#### **Addendum 43 – Regulation No. 44**

#### **Revision 3 - Amendment 4**

#### **Uniform provisions concerning the approval of restraining devices for child occupants of power-driven vehicles ("Child Restraint Systems")**

"4.9. Marking of a booster cushion without backrest.

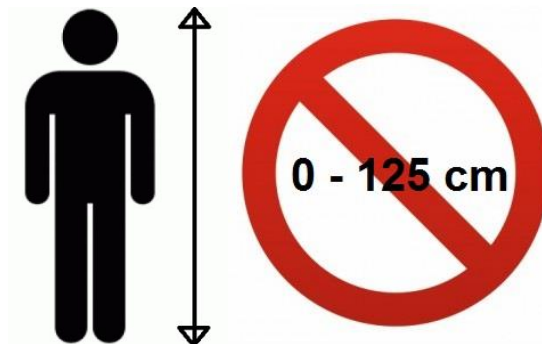
Insert a new paragraph 4.9., to read:

If the product is a booster cushion without backrest, the following label shall be permanently visible to someone installing the restraint in a vehicle and shall be masked when the booster cushion is used with its removable backrest :
